# Access Compliance Report

## Public Rights-of-Way

| Intersection ID: N/A                    | Main Street: ROCK_ISLAND_RD | Cross Street: AGNEW_DR                  | Location: N            |
| ADA ID: 7928A26A64B5                    | Ramp Type: Perp             | Initial Pass/Fail: Fail                 | Overall Compliance: No |

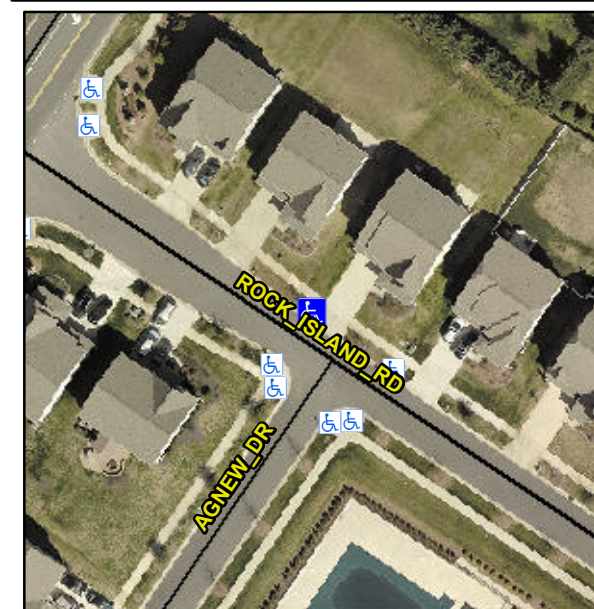
**Not Found, R304.5.1, R304.5.3**

| Compliance | Description           | Data  | Compliance | Description                 | Data |
|------------|-----------------------|-------|------------|-----------------------------|------|
| No         | Ramp Width (in)       | 45.5  | No         | Ramp XSlope (%)             | 8.8  |

**Remove & Replace Entire Ramp.**
